SUBJECT: Southern California Edison Company's Response to Notice of Violation
- NOV_CAD_SCE_YLO_20250507_1307

Finding: Completeness

Notice	Violation	Structures
NOV_CAD_SCE_YLO_20250507_1307	1	4491276E
	2	4409343E
	3	4491270E
	4	4491271E

Photo 2 – Covered Conductor Installation Structure ID 4409343E

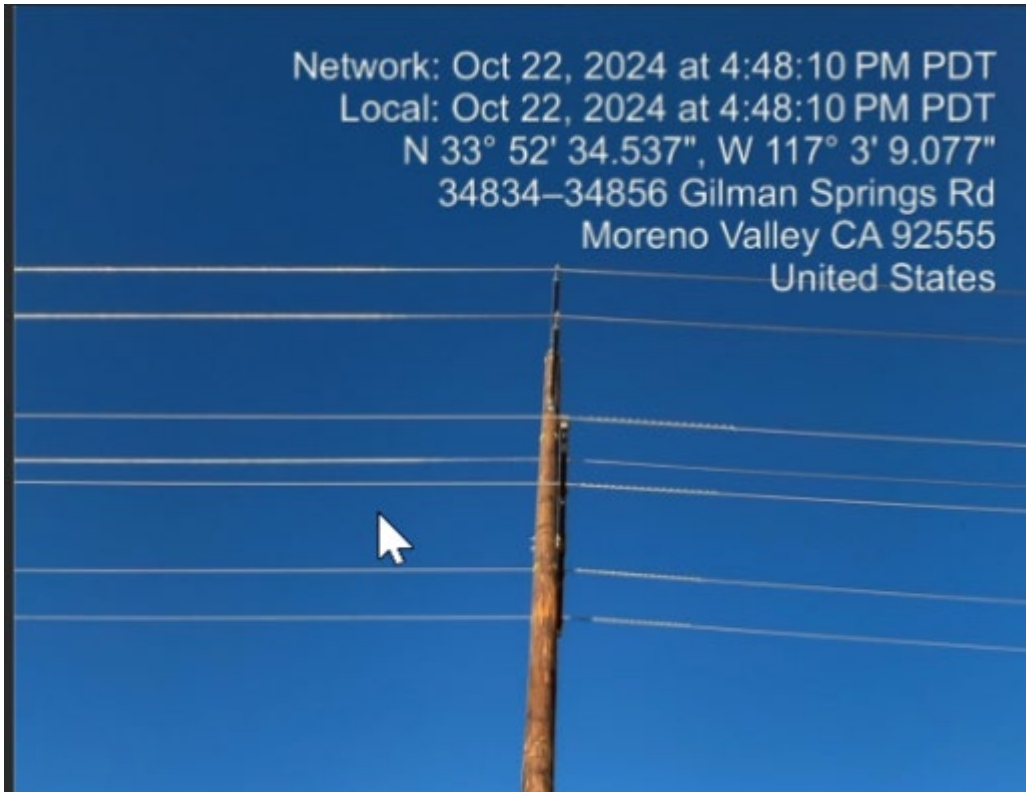
Violation 2. Energy Safety observed that in implementing 2024 WMP initiative Distribution High Fire Risk-Informed (HFRI) Inspections and Remediations, SCE failed complete the installation of wildlife covers on pole ID 4409343E, Grid Hardening ID 410902966-4409343E at coordinates 33.8762343885424, -117.052504766644.

The notification for structure IDs 4491276E, 4409343E, 4491270E, and 4491271E specified the installation of bird guards to address potential avian contact risks. Upon further evaluation, SCE personnel determined that the installation of covered conductor on the center phase would provide a more effective solution. As shown in the photos below, the covered conductor was installed in October 2024 in place of the originally planned bird guards.

Covered conductor serves the same core function as a bird guard - preventing wildlife contact and mitigating avian related outages - but it does so by fully insulating the energized conductor, rather than shielding a localized jumper connection. This continuous insulation offers enhanced protection by eliminating exposed energized surfaces along the span, thereby exceeding the original scope and intent of the planned bird guard remediation.

Photo 3 – Covered Conductor Installation Structure ID 4491270E

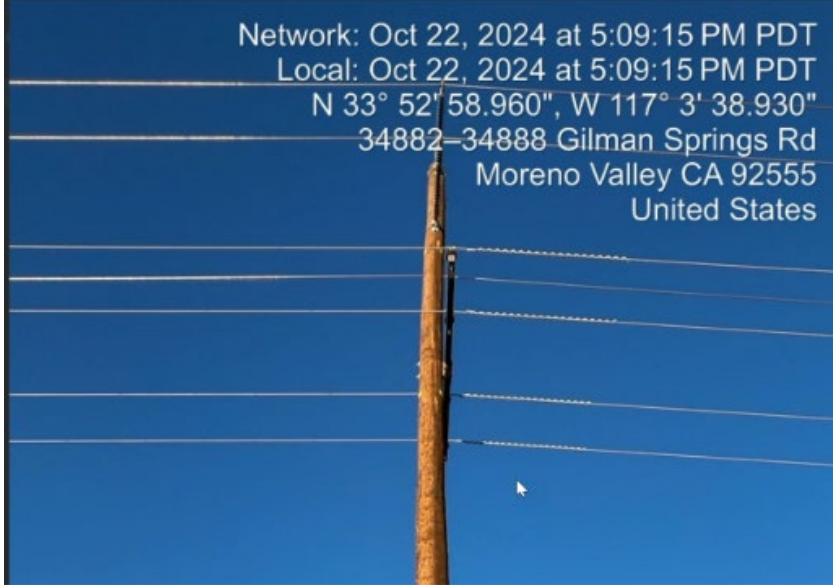
Violation 3. Energy Safety observed that in implementing 2024 WMP initiative Distribution High Fire Risk-Informed (HFRI) Inspections and Remediations, SCE failed to complete the installation of wildlife covers on pole ID 4491270E, Grid Hardening ID 410903697-4491270E at coordinates 33.8830308626952, -117.060798967357.
